Product Change Notice (PCN)

PCN Number: PCN-0450965R-01

Product(s) Affected: *MJ1-2503A*

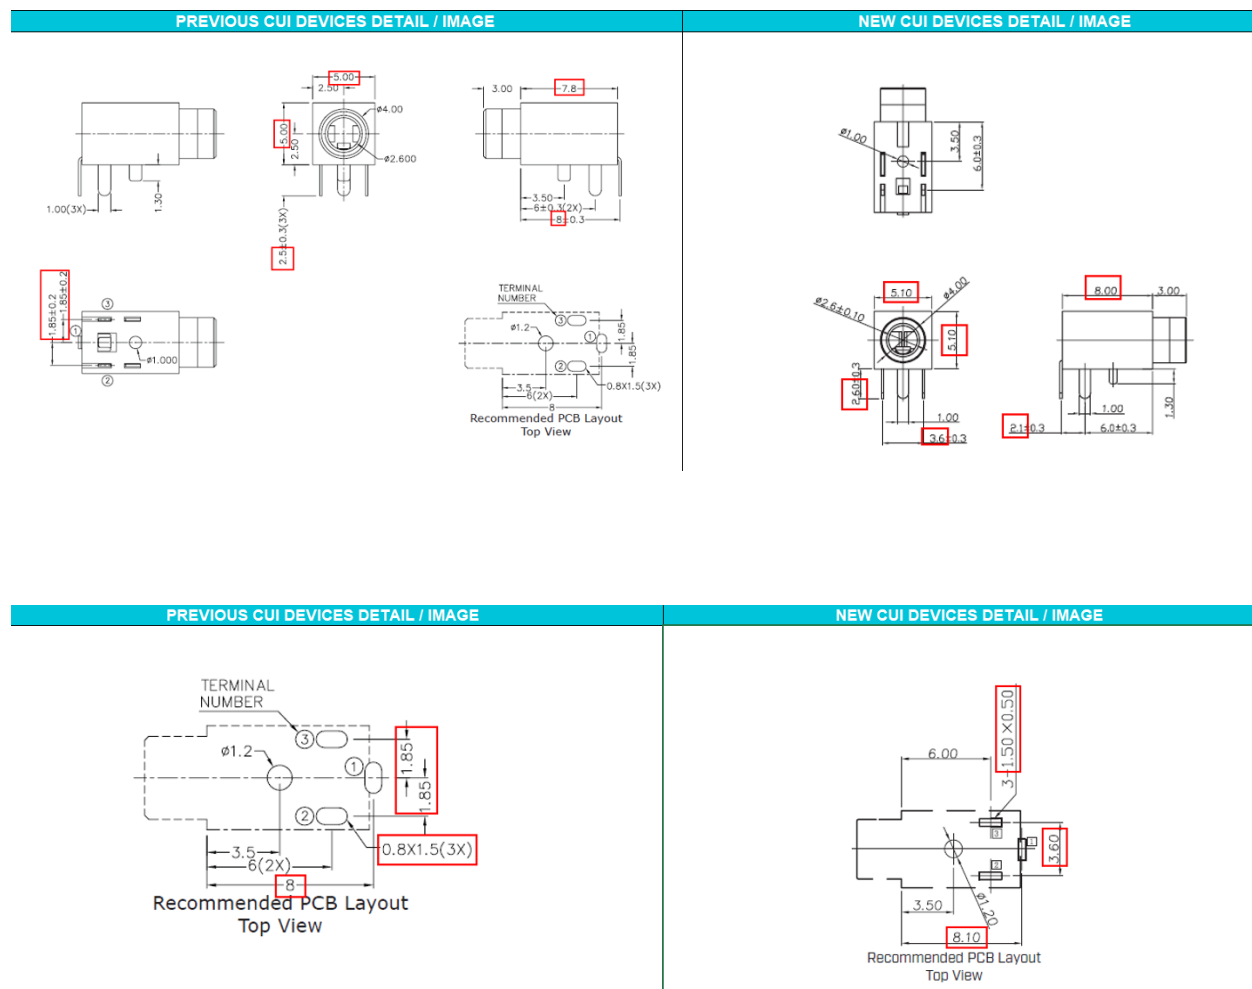
Description of Change: *Minor Layout and Material Difference. See image Below*

PREVIOUS CUI DEVICES DETAIL / IMAGE			NEW CUI DEVICES DETAIL / IMAGE		
	MATERIAL	PLATING			
terminal 1	copper alloy	silver	terminal 1	bronze	silver
terminal 2	copper alloy	silver	terminal 2	bronze	silver
terminal 3	copper alloy	silver	terminal 3	bronze	silver
bushing	brass	nickel	bushing	brass	nickel
plastic	PBT		housing	PBT (UL94V-0)	black
